Addendum # 2
to
OSPM Fire and HVAC Upgrade, Bid # 1994742-05

**OREGON STATE PENITENTIARY MINIMUM SECURITY
FIRE AND HVAC UPGRADE**

Project Number 215003

Subject Addendum #2 to the Bidding Documents

E-ROOF7.DWG

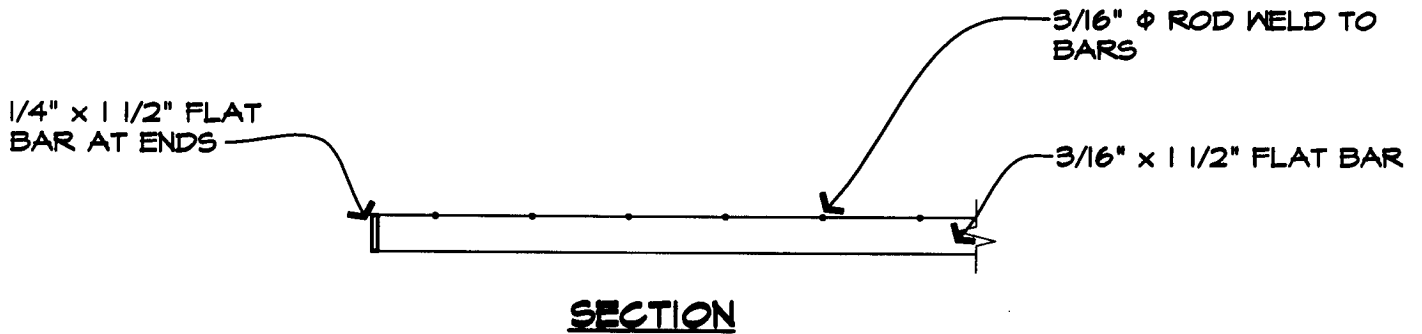
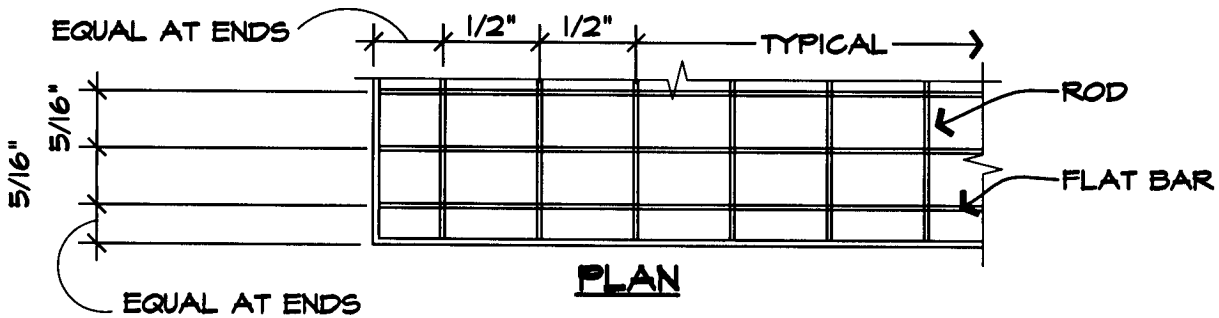
- Item 12: **Section 01030-1 & 2:** Revise portion of 3.01. A.1 to read the following: “...after completion of Base Bid Roofing repairs. Schedule work to commence upon the advent of dry weather. In the event ...”
- Item 13: **Section 13280-1:** Delete 1.03 Base Bid paragraphs 1 & 2. Work described by paragraphs has already been completed under separate agreement.
- Item 14: **Section 15260-1:** Revise 1.02.C.1 to read the following: “Insulation of domestic water piping where impacted by previous asbestos abatement and removal of heating coils.
- Item 15: **Detail 713 A & B:** Details 713 A & B are referenced by detail 738. Add detail to Project Manual.
